140 MW Solar Photovoltaic Project in Rajasthan

Report ID	VKU.VER.229.25_VCS_1709
Project title	140 MW Solar Photovoltaic Project in Rajasthan
Project ID	1709
Verification period	01-December-2023 to 30-June-2025 (Inclusive of both dates)
Original date of issue	02-December-2025
Most recent date of issue	02-December-2025
Version	02
VCS Standard	V4.7

VKU Certification Pvt. Ltd. (hereinafter referred to as VKU) has been commissioned by Climera Carbon Private Limited to conduct the seventh verification of the greenhouse gas emission reductions reported for the "140 MW Solar Photovoltaic Project in Rajasthan" project activity (VCS ID 1709) in India. The verification covered the monitoring period from **01-December-2023 to 30-June-2025 (inclusive of both start and end dates)**, within the first crediting period from 18-July-2017 to 17-July-2027 (inclusive of both start and end dates). This verification has been undertaken in accordance with relevant requirements for VCS activities.

ORGANOGRAM SWREL O&M TEAM (Rising Bhadla 1 Pvt Ltd)

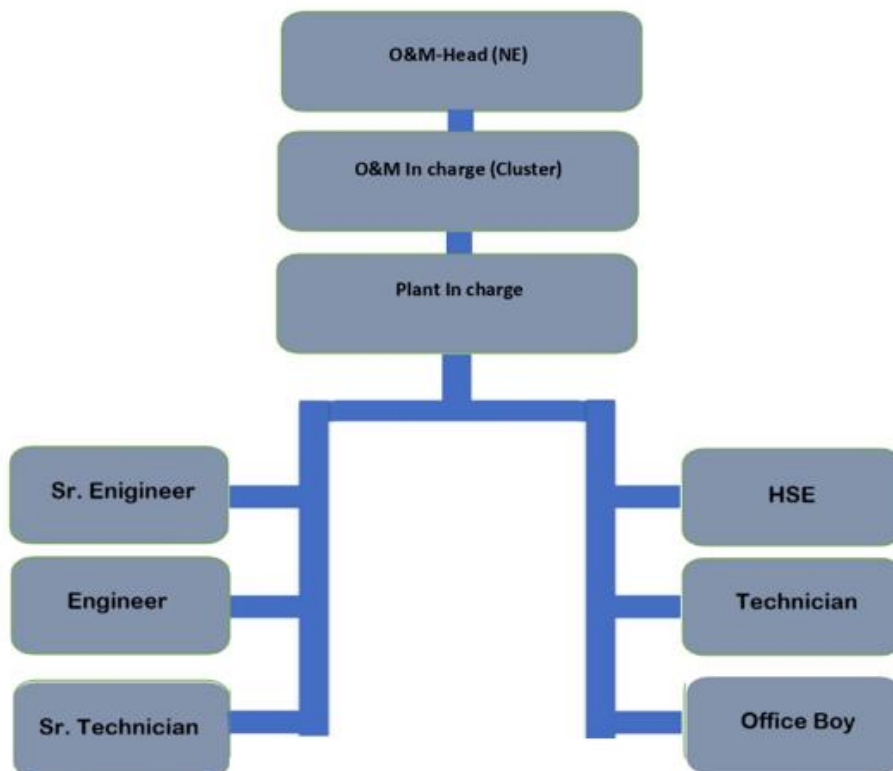
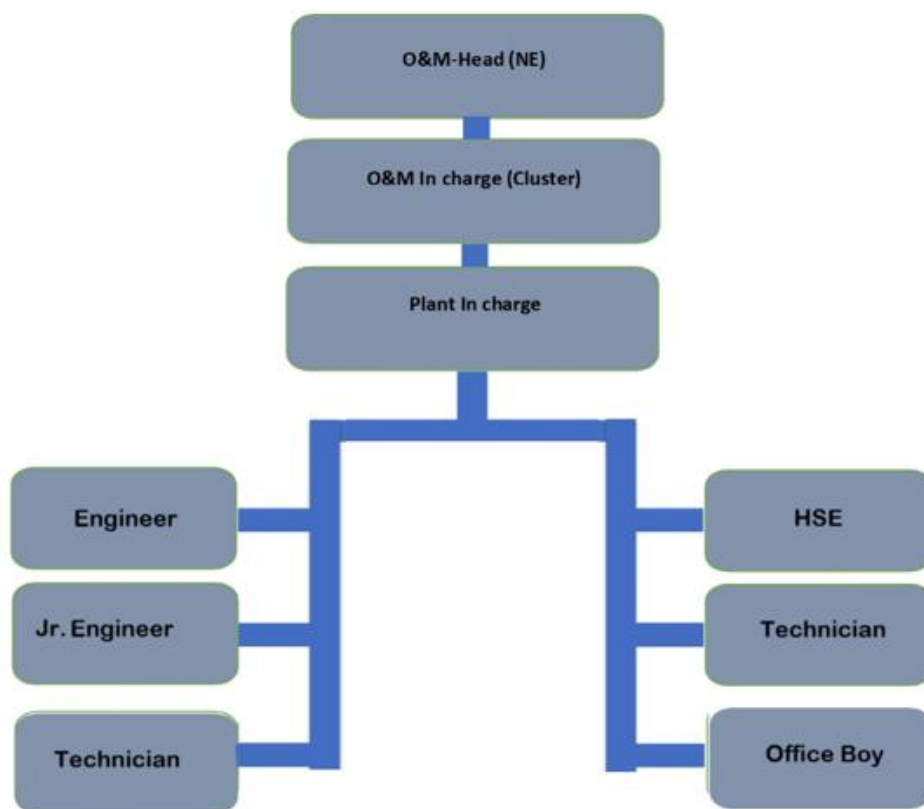
Deviation 02: During the verification process, it has been identified that the O&M structure differs from that described in the registered VCS PD. So, the exact O&M structure of the Project Activity has been changed. The change has been shown below –

The Verification team has reviewed these deviations against the documentary evidences and approved previous verification reports/5/ available at Verra project webpage. It has been verified from the organisational structure flow chart provided by PP/38/ and cross verified through interviewing the concerned personnels during remote audit by the assessment team. Hence VVB has confirmed this deviation. Also, there is no impact of the same on additionality, baseline scenario & emission reduction calculation of project.

6. The value is now corrected in the revised MR.
7. The statement is now revised.
8. The O&M Structure is now updated in the section 4.3 of MR.
9. As the statement has typographic mistake, hence it is now removed.

#OPEN
8. O&M structure of the Rising Bhadla 1 and 2 has been revised in MR which has been assessed as per the scenario observed during the remote audit and it is found to be correct hence, accepted.
